REMEDIATION SYSTEM EVALUATION (RSE)

GCL TIE AND TREATING SUPERFUND SITE SIDNEY, NEW YORK

Report of the Remediation System Evaluation
Site Visit Conducted July 13, 2006

FIGURE 1-1. SITE MAP WITH WELL LOCATIONS

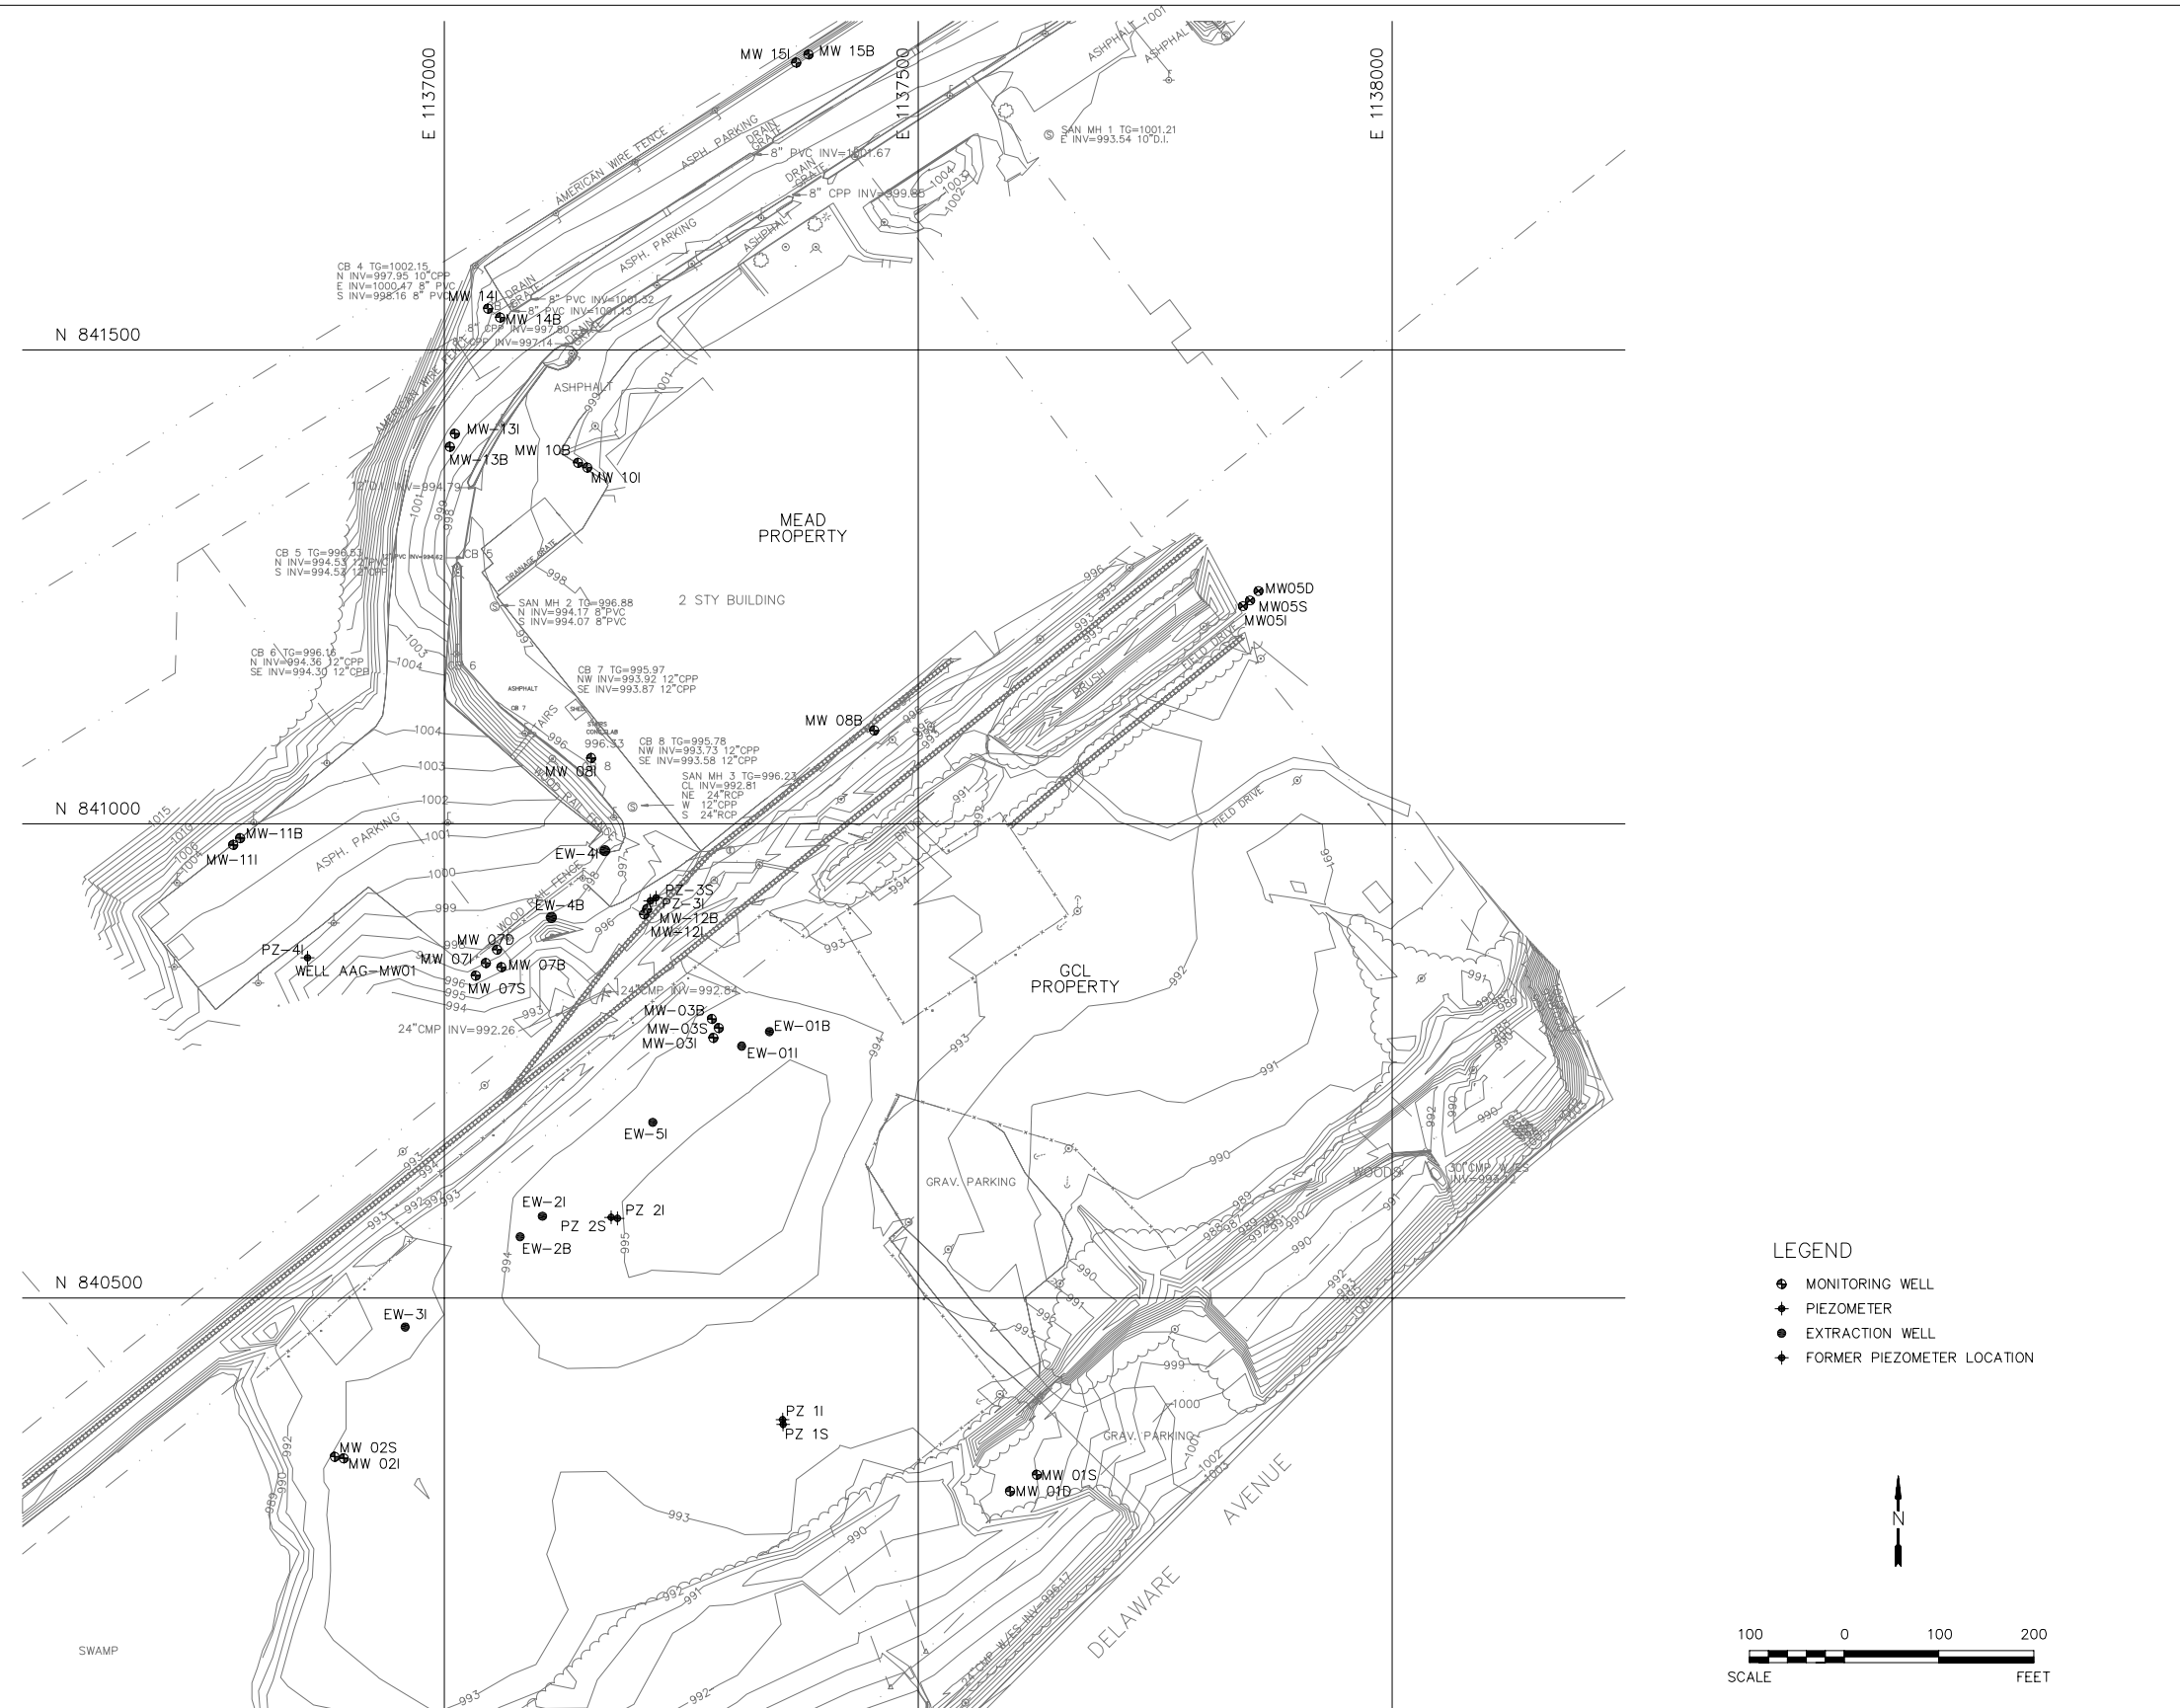
- A routine ground water monitoring program that consists primarily of annual sampling from site monitoring wells should be established.
- An additional monitoring well could be added downgradient of MW-11B to horizontally delineate the naphthalene plume in the bedrock aquifer. The plume is currently not delineated in this area; however, the naphthalene concentrations at MW-11B are only a factor of two above the

cleanup standard, and conservative transport modeling suggests that the contamination likely degrades within a few hundred feet of MW-11B. Therefore, the additional monitoring well may or may not be necessary depending on how rigorously EPA would like to demonstrate plume delineation.

EW-2B is directly upgradient of MW-11B and pumps at a rate of greater than 13 gpm. Using the capture zone calculations presented earlier, this translates to an estimated capture width of approximately 2,600 feet. As a result, the RSE team believes that source area contamination is adequately contained and that one of the first two possibilities noted above is the explanation for these relatively consistent concentrations at MW-11B. Continued ground water monitoring may help confirm adequate capture or indicate potential deficiencies in the extraction network.
